instruction manual revision

68P81071E50-A

68P81078E15-0	RADIUS R100 (RT) STATION
68P81071E50-A	RADIUS R100 (RT) STATION
TDN7406A	TELEPHONE INTERCONNECT MAN.

PHONE PATCH/EXTENDED LOCAL CONTROL WIRING DIAGRAMS

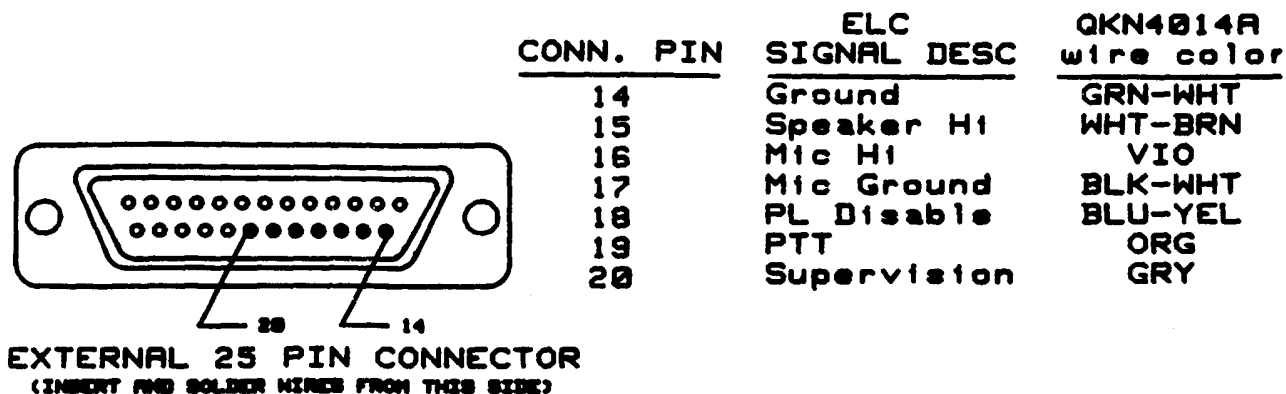
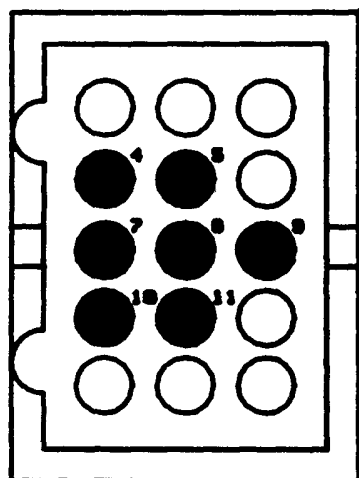
BRN lead (PIN 13) Moved to U801-9

NOTE: WHEN BOTH PHONE PATCH AND ELC ARE BEING INSTALLED
ADAPTER CABLE QKN4014A MUST BE ADDED TO PHONE
PATCH CABLE (25 PIN END)
